7-ELEVEN

DEVELOPMENT PLAN
7-ELEVEN
LOT 1, ACADEMY GATEWAY SUBDIVISION FILING NO. 1
BUILDING ELEVATIONS

PROJECT NO: C7-003
DESIGNED BY: AEG
DRAWN BY: AEG
DATE: 12/04/2017

C5.0
SHEET 10 OF 16

1 FRONT ELEVATION
SCALE 3/16" = 1'-0"

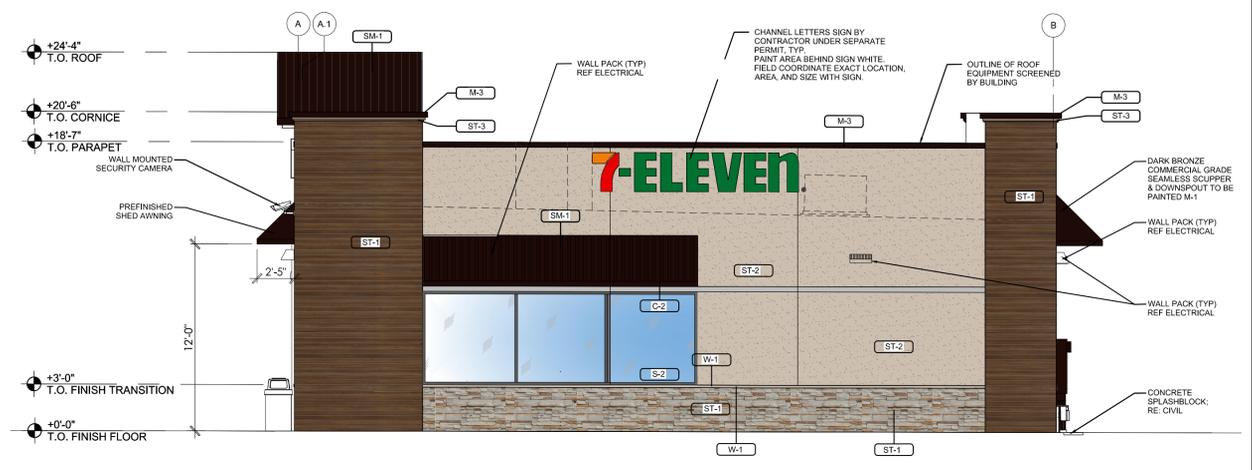
What color and material-metal bronze finish (M-2)? ACM is not on the key.

Stone Veneer is labeled but not depicted. It looks like wood? Which is it?

2 RIGHT ELEVATION
SCALE 3/16" = 1'-0"

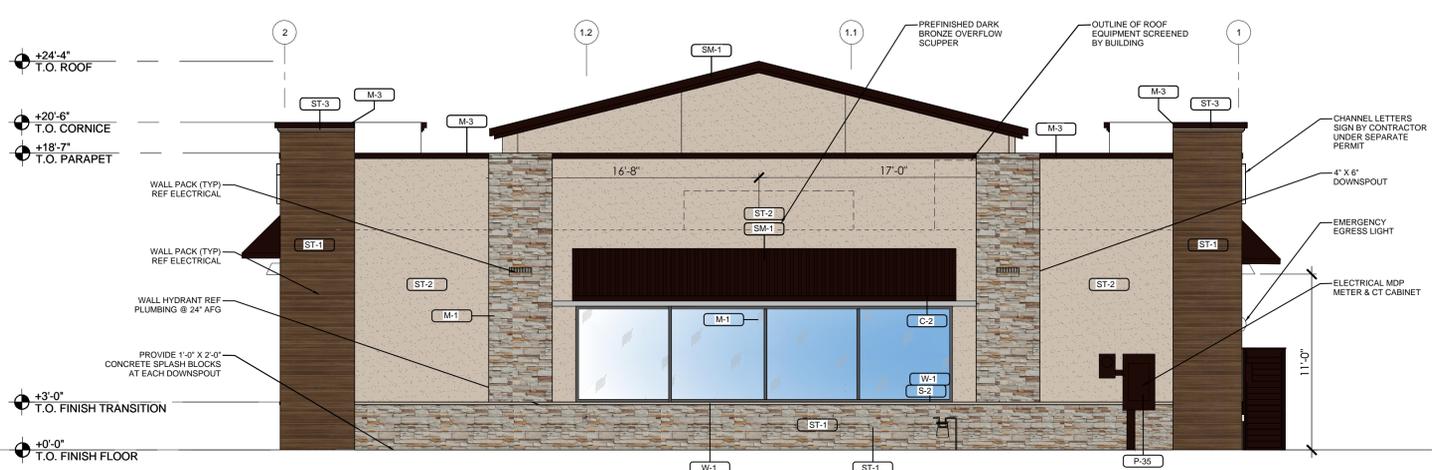
What color and material-metal bronze finish (M-2)? ACM is not on the key.

Is this stone veneer ST-1?
